West Orange Township – Zoning Board
66 Main Street
West Orange, NJ 07052

**Re: Mavis Tire – Planning Review #1
460 Prospect Avenue
Block 105, Lot 64.01
Zone: B-2 General Business
Our File No. 115.WRZ0105.V01**

Figure 2: Sidewalk / lack of sidewalk on Prospect Avenue

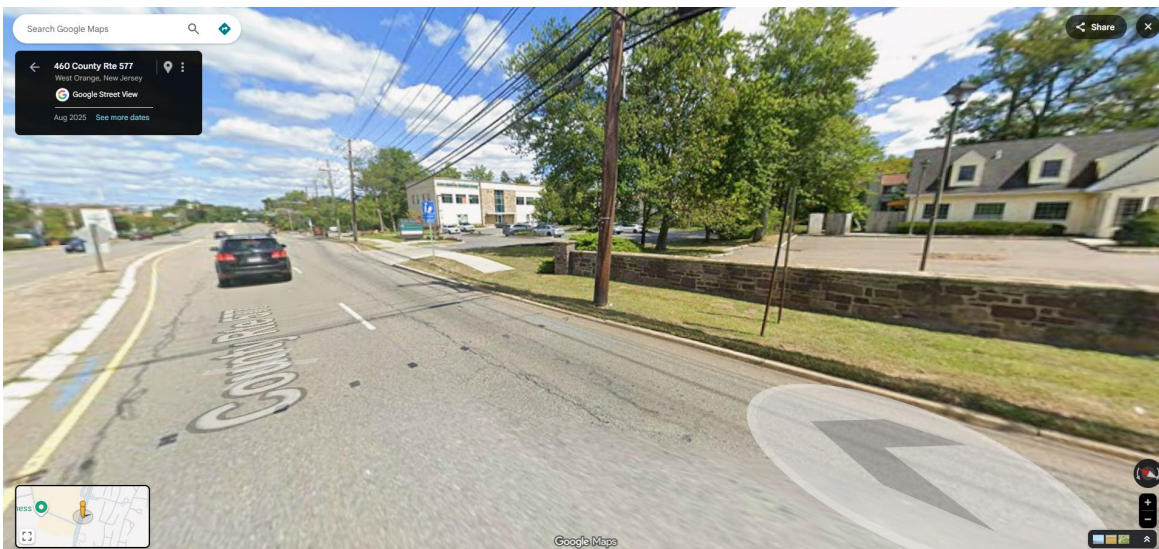
- j. Will there be any differentiation between employee parking and customer parking? The applicant should clarify.
- k. The applicant has requested a variance for having the drive aisle setback as 0 feet from a side yard where 5 feet is required. We note that the property's southern side lot line is actually the centerline of Blueberry Bend, a private road, making any drive aisle providing access to the roadway technically in violation of the code.
- l. It does not appear that any sidewalk is proposed for the Prospect Avenue frontage of the site. While this is an existing condition, we note that there is sidewalk along the frontage immediately north of this site, and to the south as well. This property and the immediate neighbor to the south represent an existing gap in the sidewalk network that could be partially addressed through this development.
